DC# 2026 0022
Lakeland School Corporation
Wolcott Mills Elementary Reroof
Addendum No. 1
May 11, 2026

3. **Item No. A-3**

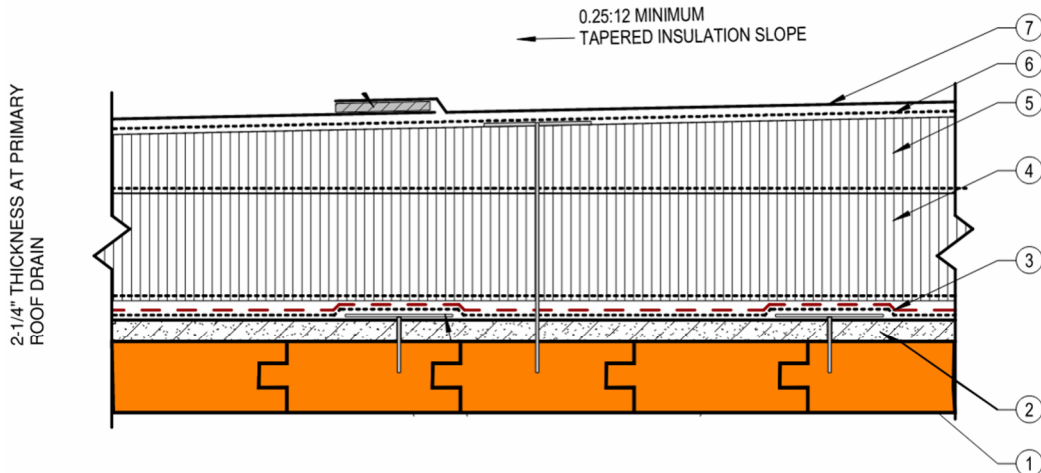
Modification: To compensate for asphalt residue that may prevent proper adhesion of the specified vapor barrier, add ¼" x 48" x 96" Georgia Pacific Densdeck Prime substrate board or approved equal direct to the top of the structural Lock Deck. Secure panels with 1-1/2" long roofing membrane manufacturer approved deck screws. Fastener quantity and pattern to resist Class 90 wind uplift loading.

Clarification: The existing structural roof deck is a 2-1/4" to 2-1/2" thick tongue and groove Lock Deck. The underside of the Lock-Deck is exposed to interior occupied spaces. The design intent is that fasteners used as part of mechanically attached insulation boards shall not penetrate the underside of the exposed roof deck.

Clarification: Fasteners lengths to secure the tapered insulation panels will vary in length and their usage will need to be closely coordinated in the field to prevent fasteners from penetrating the underside of the decorative roof deck. It is highly recommended that installing contractors closely field supervise fastener length usage with their installing crews. Tapered insulation board fasteners shall penetrate the structural Wood Lock Deck a minimum of 1" to a maximum of 1-1/4".

Notification: Where fasteners extend through the underside of the Lock Deck the fasteners, at the contractor's expense for material and labor, shall be cut and grinded off to be slightly recessed. The tips of the fasteners to be spot primed. Holes to be filled with color matched epoxy wood filler or tinted wood plugs. Affected areas between trusses shall be sanded complete, pre-conditioned and re-stained with color matching stain.

Clarification: At the primary roof drain locations, Bidding contractors to assume a ¼" thick substrate board, vapor barrier, 1-1/2" flat stock fill panel and a tapered "X" panel for a total start thickness of 2-1/4" at the roof drains.

- 1. EXISTING 2-1/4" TO 2-1/2" LOCK DECK
- 2. 1/4" SUBSTRATE BOARD, MECHANICALLY ATTACHED WITH 1-1/2" LONG SCREWS
- 3. ADHERED VAPOR BARRIER
- 4. 1-1/2" POLYISOCYANURATE FILL PANEL LOOSE LAID
- 5. TAPERED POLYISOCYANURATE PANELS MECHANICALLY ATTACHED. MIN 1" TO MAX 1-1/4" FASTENER PENETRATION INTO STRUCTURAL DECK.
- 6. TPO ROOF MEMBRANE ADHESIVE
- 7. TPO ROOF MEMBRANE WITH HEAT WELDED SEAMS

4. **Item No. A-4**

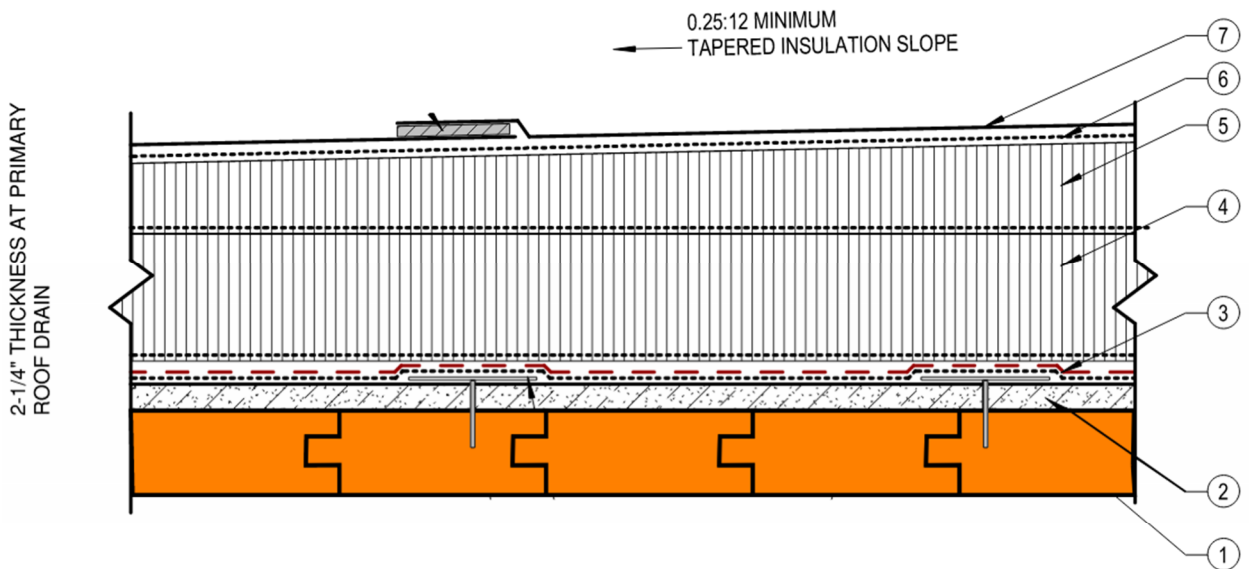
- d. Addendum Item: An acceptable option to the specified TPO roof system includes the following:
 - Roof membrane materials & attachment methodology: Same as notated on A2.1

- Tapered Insulation panels & attachment methodology: Adhered with adhesive per roofing membrane manufacturer recommendations. All other information remains the same as notated on A2.1.

- Fill Panel Materials and attachment methodology: 1-1/2" fill panels adhered with adhesive per roofing membrane manufacturer recommendations. All other information remains the same as notated on A2.1.

- Temporary Roof/ Vapor Barrier material & attachment methodology: Direct applied to a substrate board per roofing membrane manufacturer recommendations.

- Substrate Board: To compensate for asphalt residue that may prevent proper adhesion of the specified vapor barrier, add 1/4" x 48" x 96" Georgia Pacific Densdeck Prime substrate board or approved equal direct to the top of the structural Lock Deck. Secure panels with 1-1/2" long deck screws. Fastener quantity and pattern to resist Class 90 wind uplift loading.

- Structural Deck: The existing structural roof deck is a 2-1/4" to 2-1/2" thick tongue and groove Lock Deck. The underside of the Lock-Deck is exposed to interior occupied spaces. Lock-Deck is supported by exposed deep wood roof trusses

- Clarification: At the primary roof drain locations, Bidding contractors to assume a 1/4" thick substrate board, vapor barrier, 1-1/2" flat stock fill panel and a tapered "X" panel for a total start thickness of 2-1/4" at the roof drains.

1. EXISTING 2-1/4" TO 2-1/2" LOCK DECK
2. 1/4" SUBSTRATE BOARD, MECHANICALLY ATTACHED WITH 1-1/2" LONG SCREWS
3. ADHERED VAPOR BARRIER
4. 1-1/2" POLYISOCYANURATE FILL PANEL ADHERED
5. TAPERED POLYISOCYANURATE PANELS ADHERED
6. TPO ROOF MEMBRANE ADHESIVE
7. TPO ROOF MEMBRANE WITH HEAT WELDED SEAMS
